Smithsonian Institution National Air and Space Museum

Construct Integrated Bezos Learning Center

United States Commission of Fine Arts:

Revised Concept Phase Project Report Submission November 7th, 2024

Concept

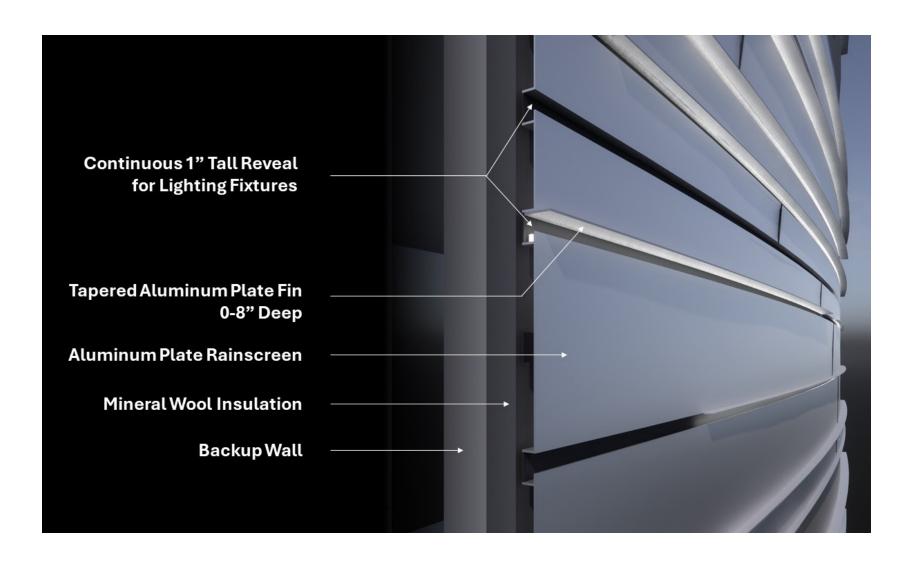
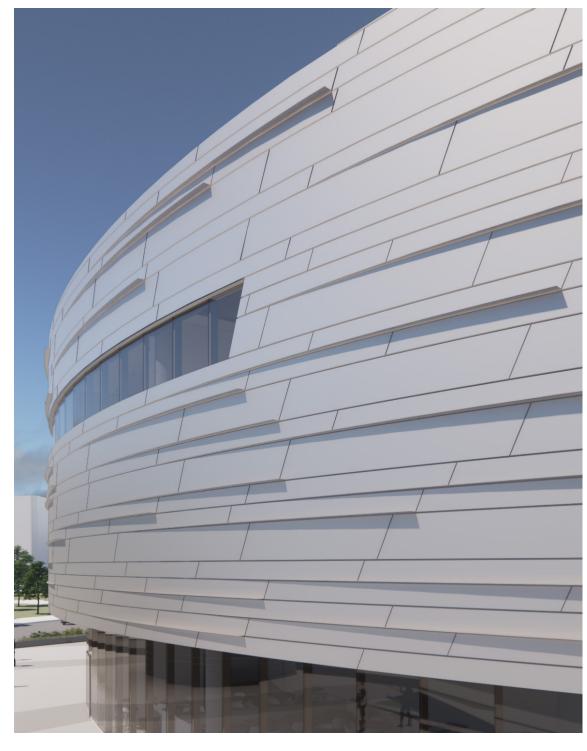
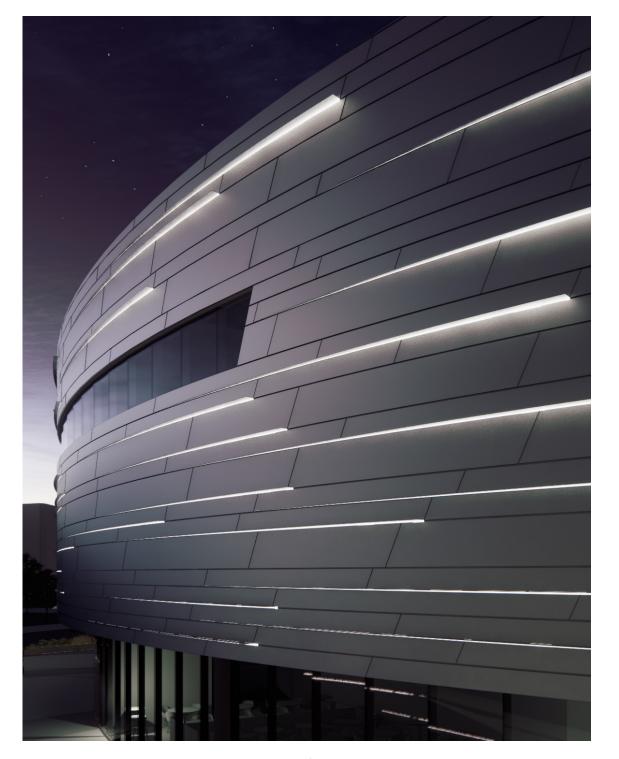
Comment: They supported the project team's preferred alternative of tapered fins with

integrated lighting, which they said would best reinforce this concept, and they suggested further study of the fin system to avoid weather-related

staining.

Noted, the project team has included further detailing of the exterior Response:

system which helps reinforce the concept while grounding it within the

historical context of NASM.

Phoebe Waterman Haas Public Observatory & Astronomy Park

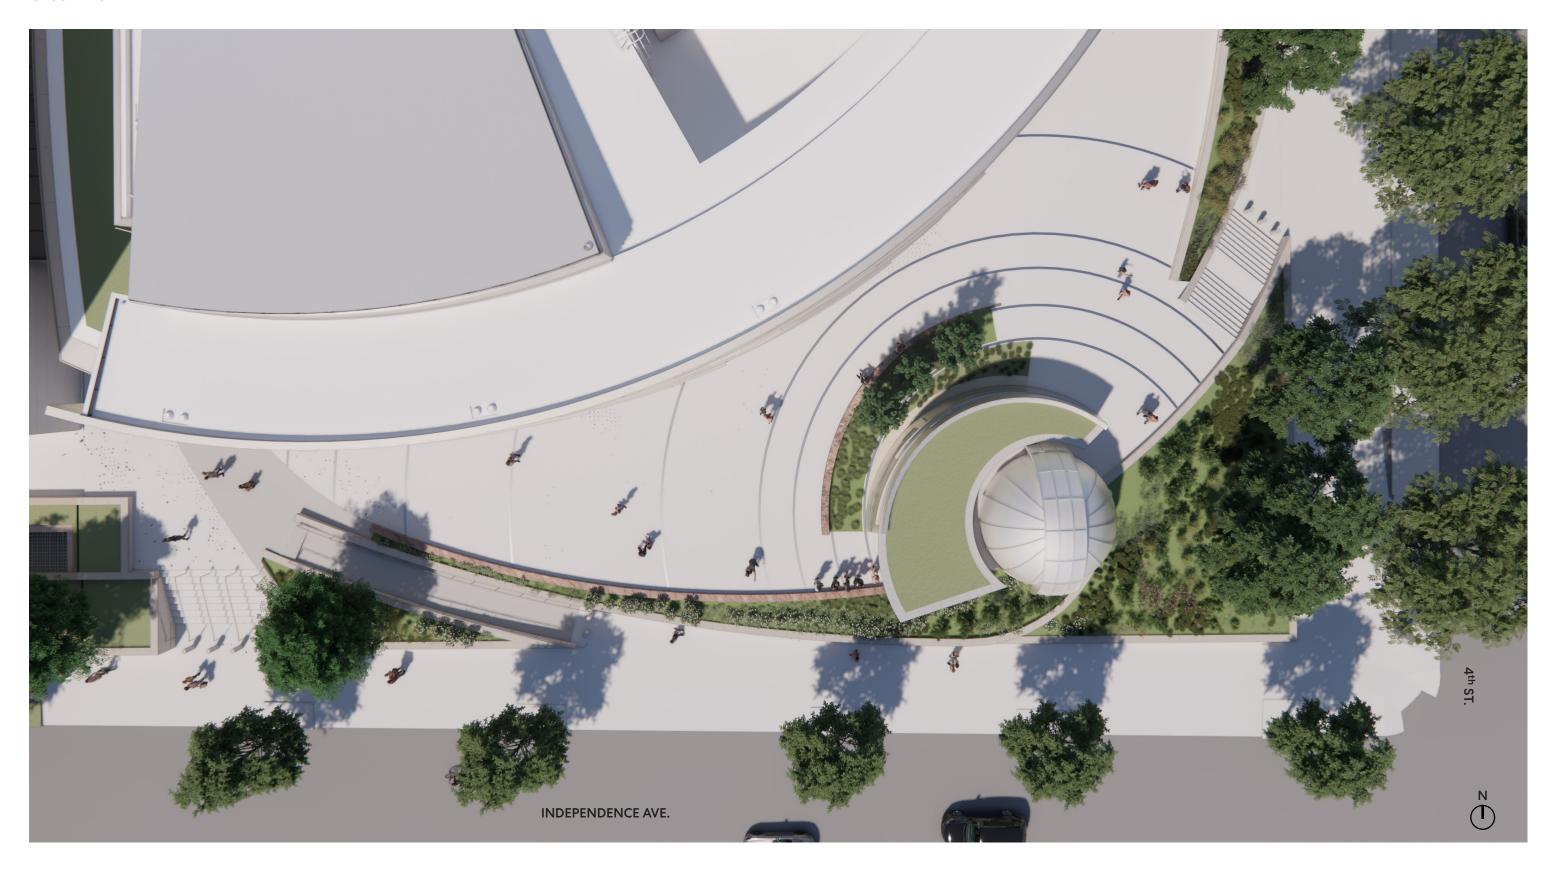
Comment: They also noted the importance of the proposed observatory as the one

place on the site where visitors will actually be able to see outer space, connecting the experience of the individual with the vast scale of the museum's mission; they suggested that its design should be developed further to emphasize the small-scale, tactile qualities of its elements and

to integrate it better into the landscape design.

Noted, the project team has furthered the integration of the observatory Response:

within the landscape

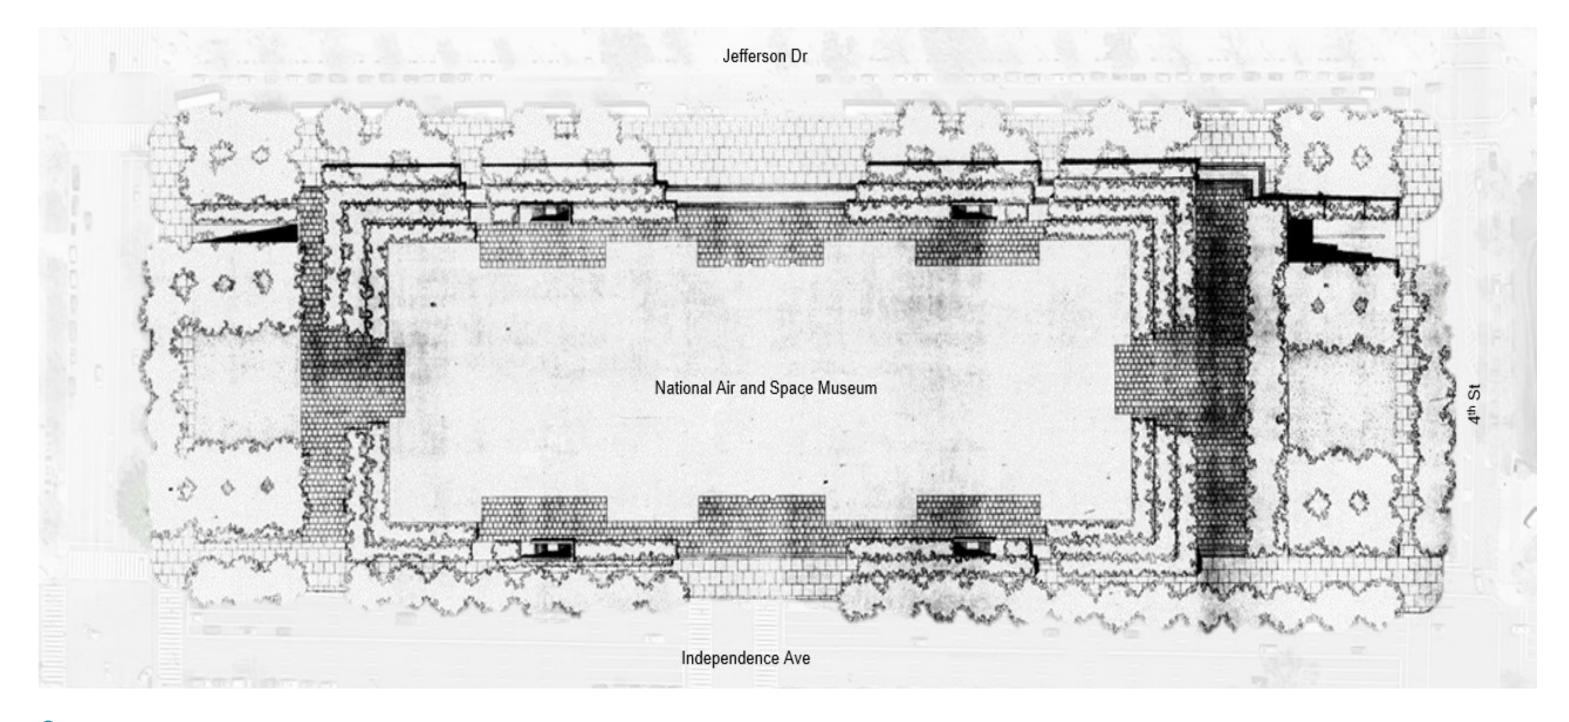
Comment: For the design of the site, the Commission members endorsed the presented

alternative that extends the spiraling formal concept outward from the architecture to the perimeter of the site; they recommended that the landscape be developed further to emphasize a sculptural quality beyond

the graphic strength of the plan. They commended the landscape design's universal accessibility, particularly of the curving ramp on the north, which will provide an equitable approach to the new addition. However, they

recommended treating this approach more powerfully than lining it with ornamental flowering trees, observing that the new pathway will intersect

at the site perimeter with the strong double row of street trees along Jefferson Drive and should establish a comparably strong threshold into the

museum landscape. For the central court, they advised the careful placement of enough trees and seating to provide seasonal shade and

comfort.

Noted, the project team has progressed the design of the Entry Ramp and Response:

Learning Courtyard to provide a more powerful approach and destination.
